LiDAR Quality Assessment Report

UT_Southern_B1_2018

Applicable Specification:
NGP LiDAR Base Specification V 1.2

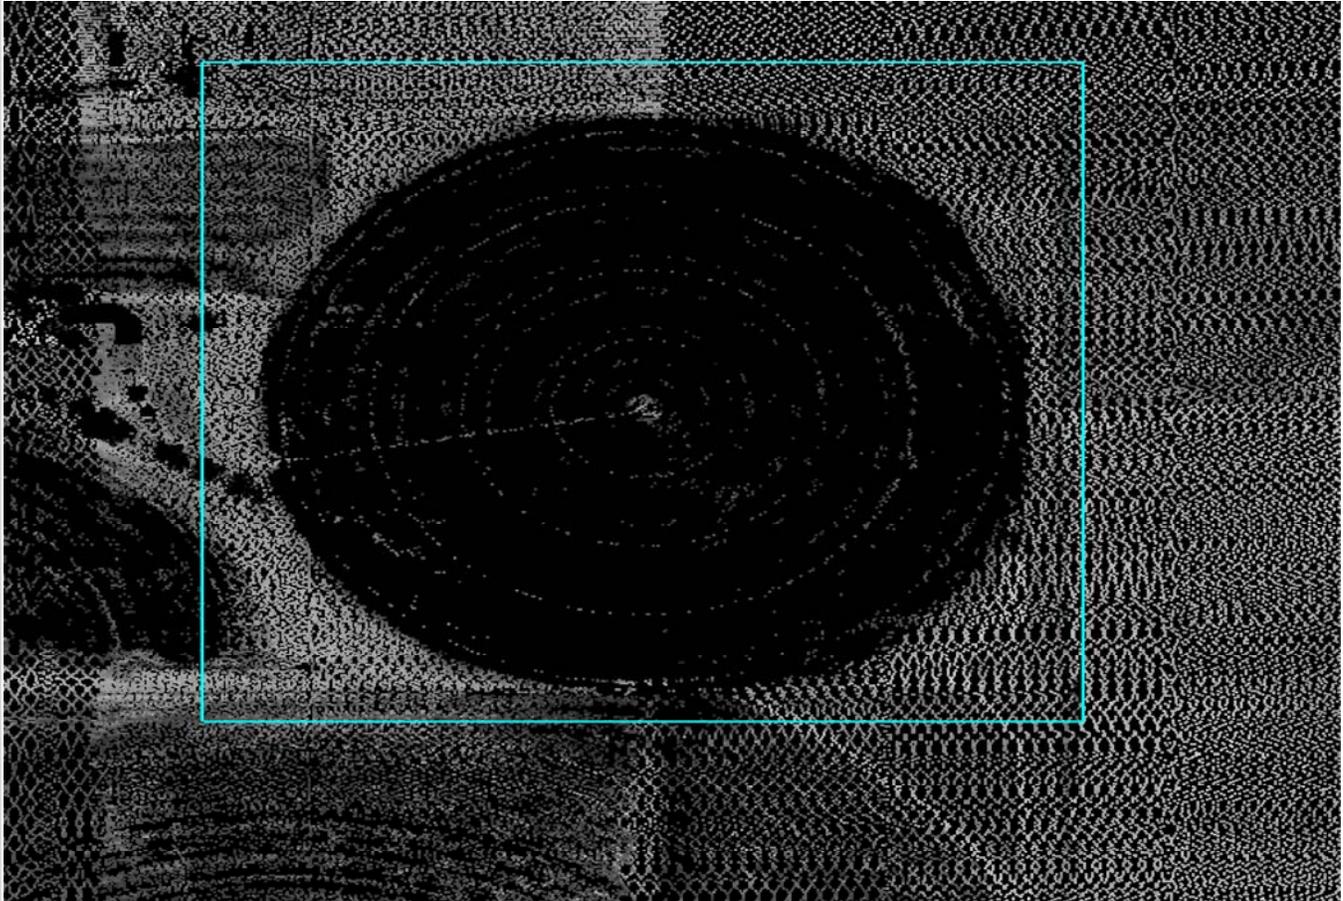
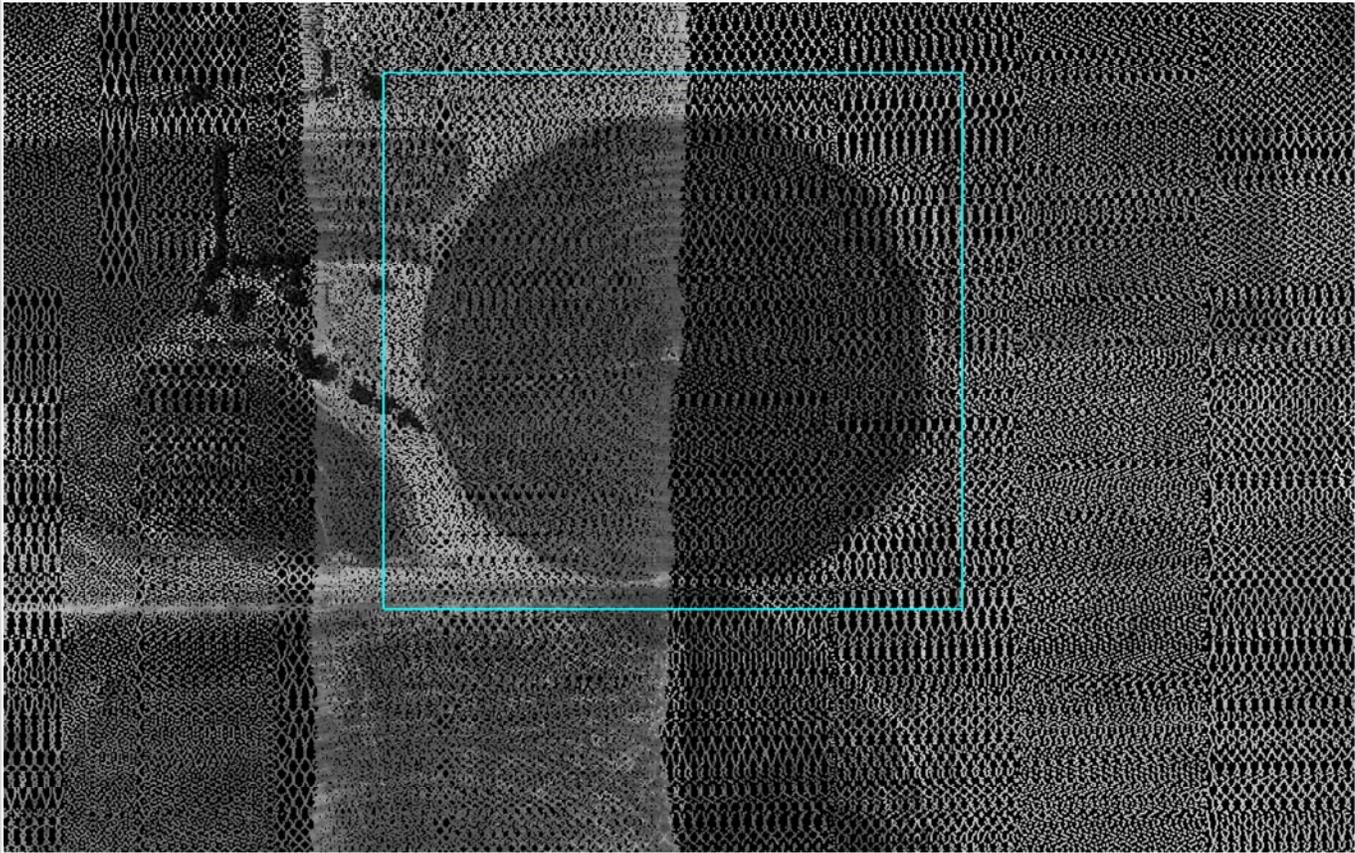
- There is one are in a crop circle where there are data voids in the DEM caused by lack of classified ground points. corrected
3/21

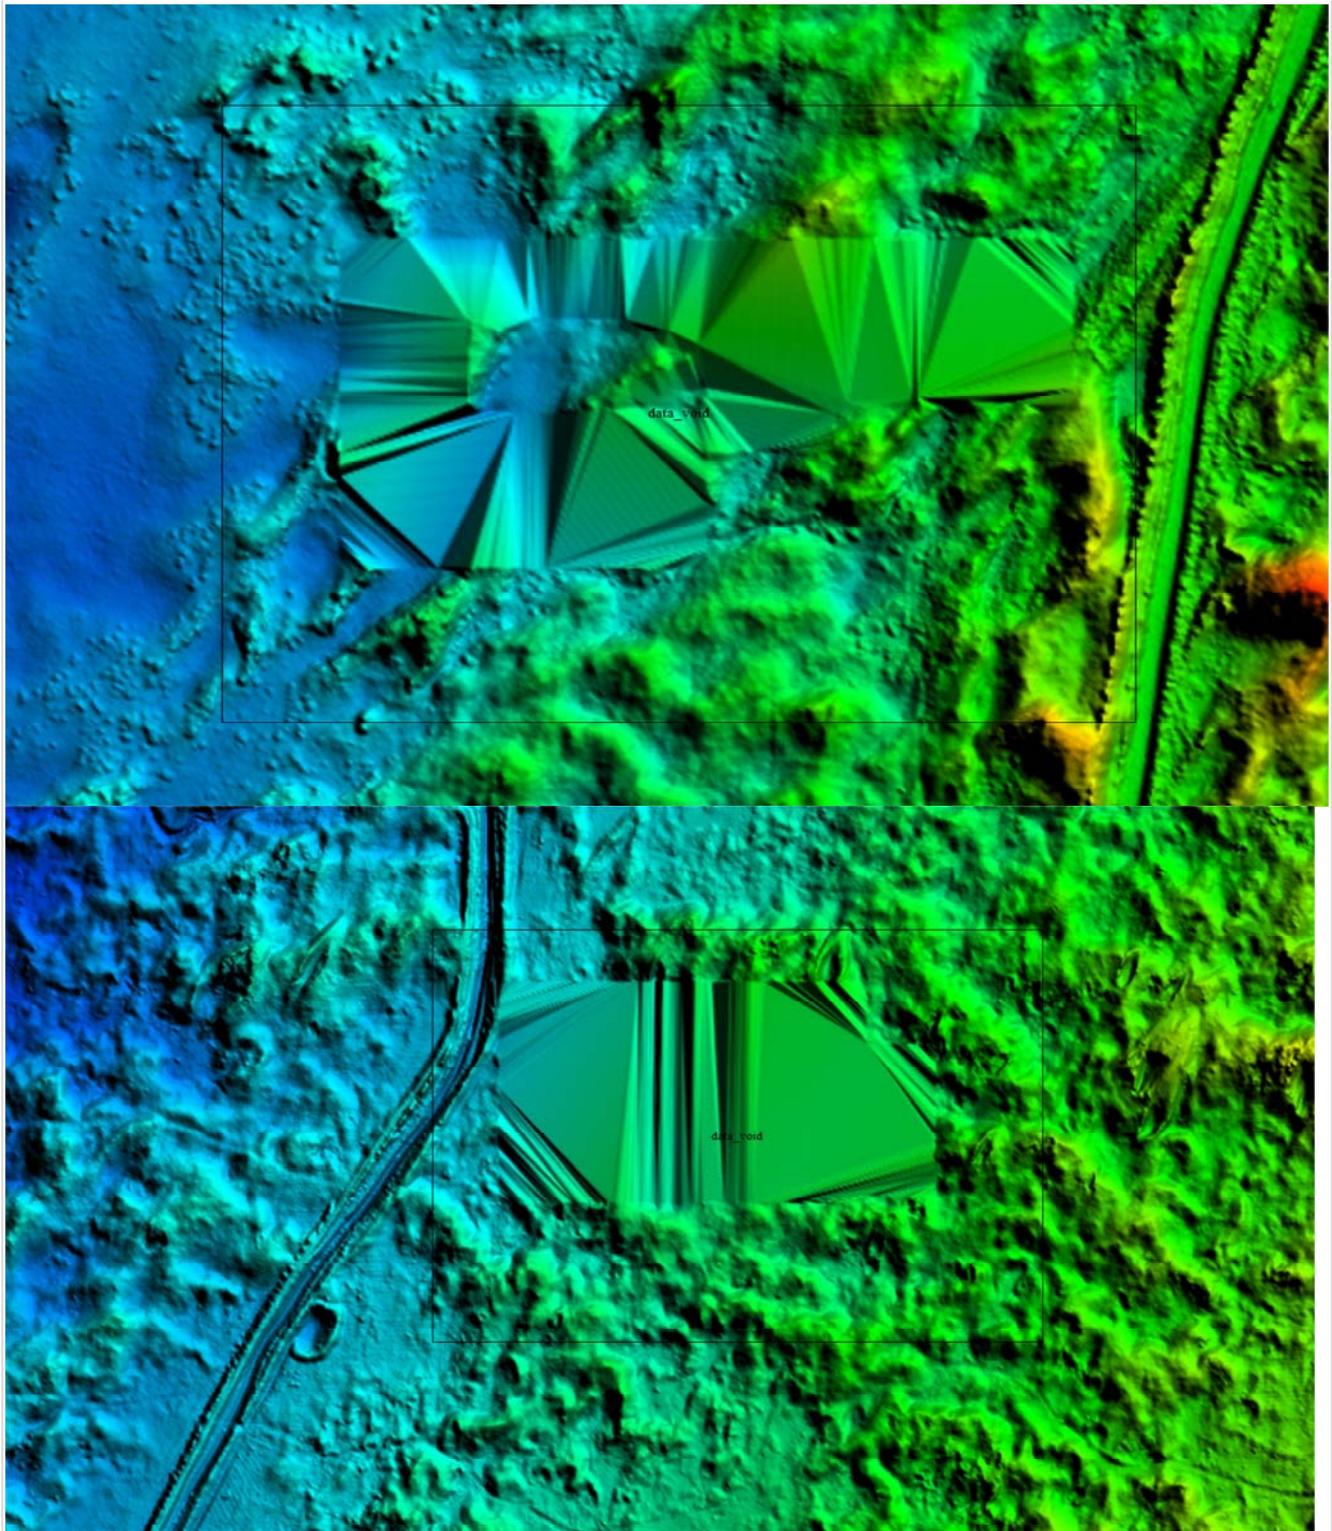
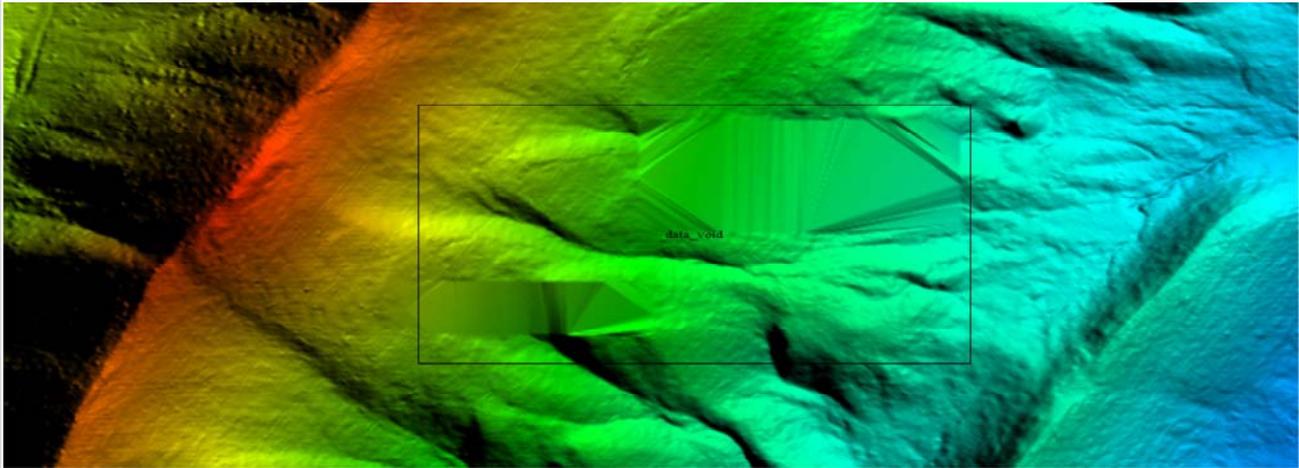
- There are 16 data voids found in the DEM. These data voids are not found in the LAS either from collection errors or classification errors. These data voids are likely the result of DEM creation issues. **corrected 3/21**

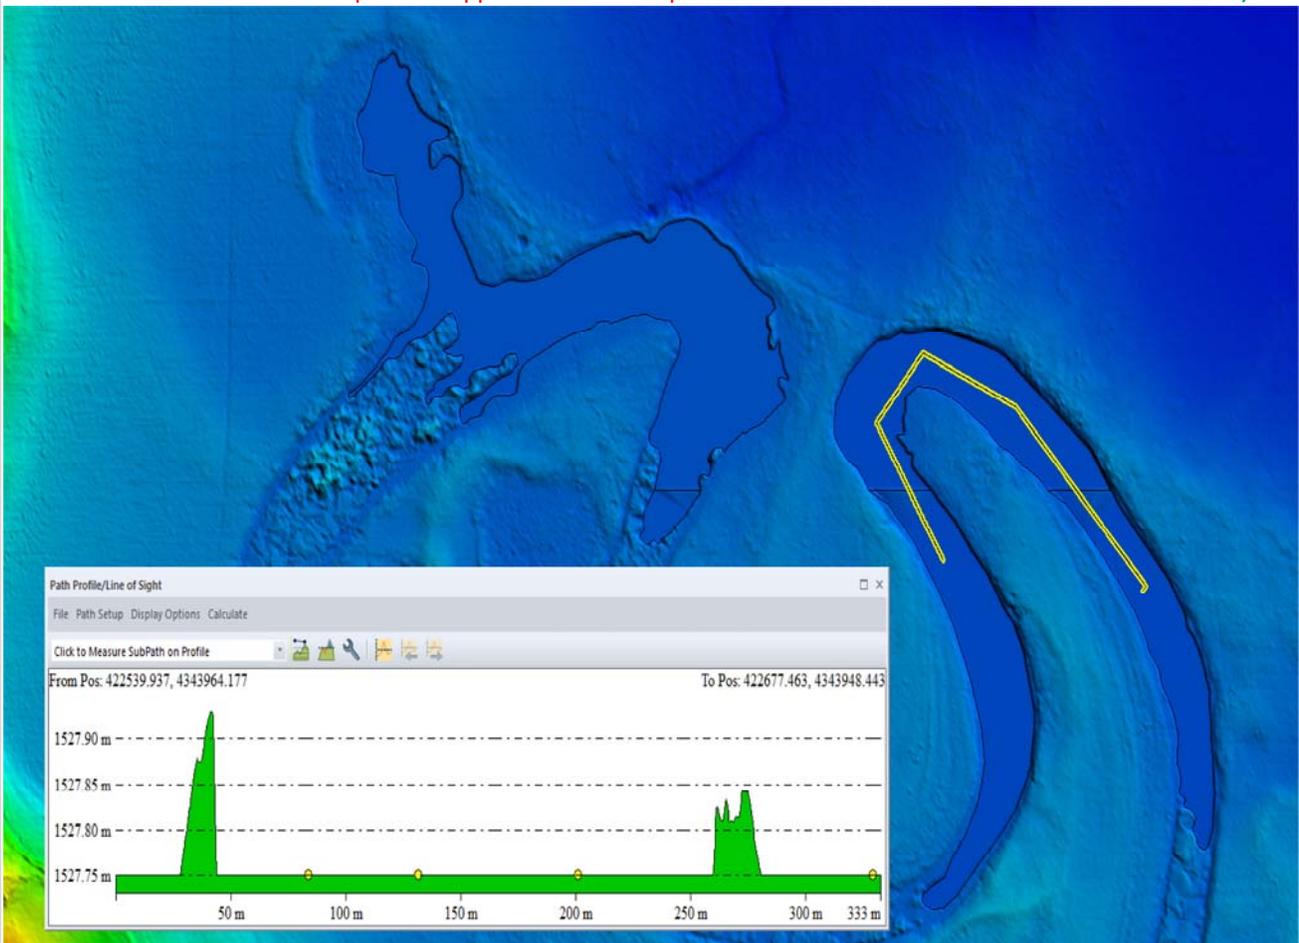
- There are two lakes that have spikes. It appears that these spikes are the result of breakline errors. **corrected 3/21**

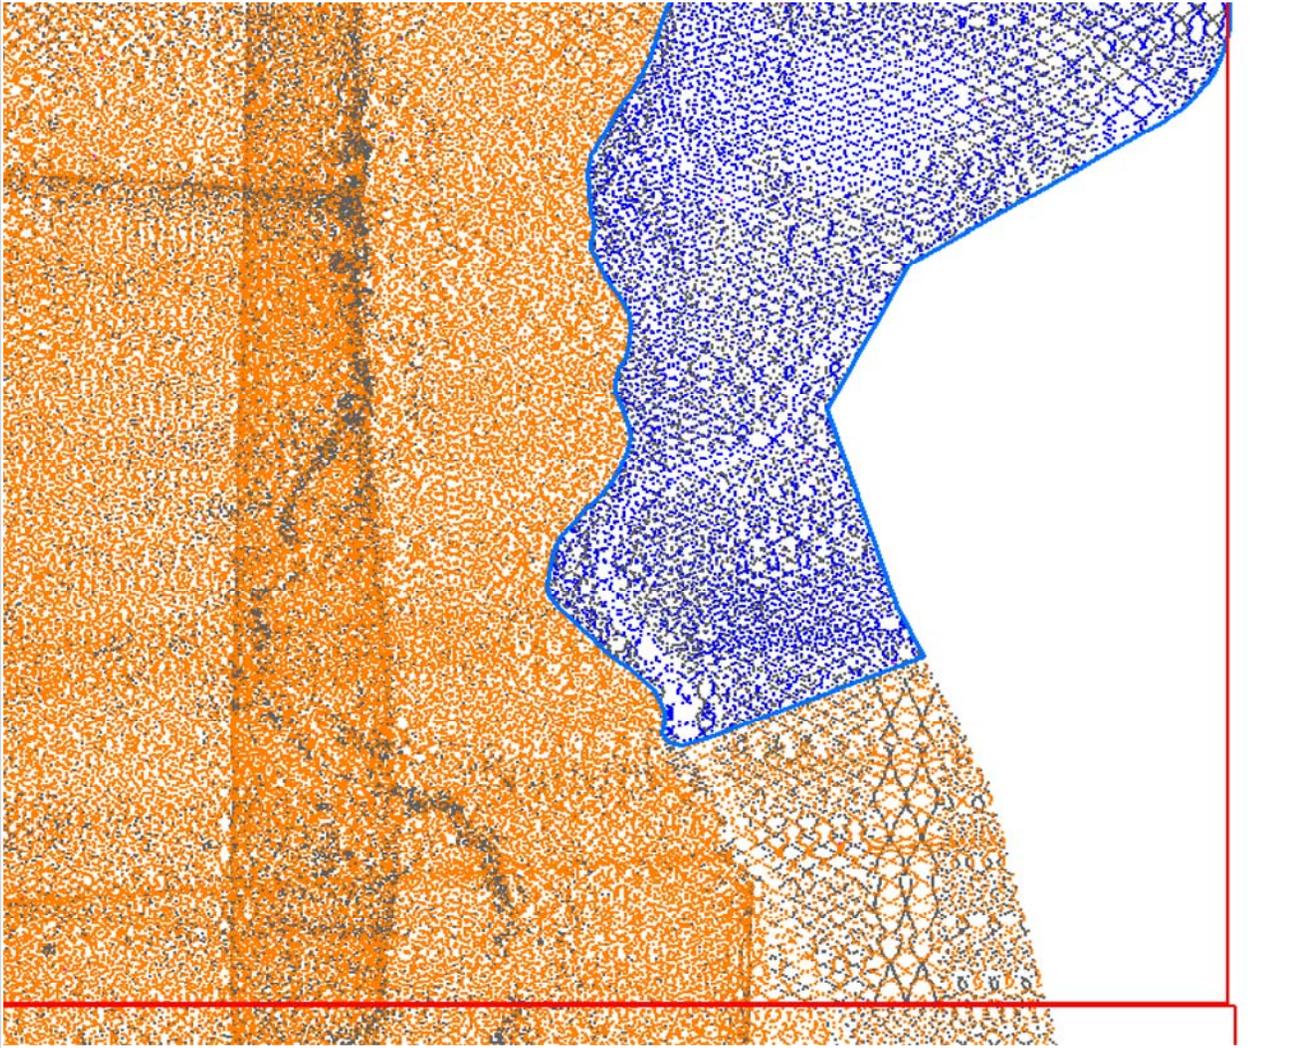
- There is a lake breakline that arbitrarily cuts off on the edge of the AOI. This breakline should either be fixed to follow the shoreline of the lake. **corrected 3/21**
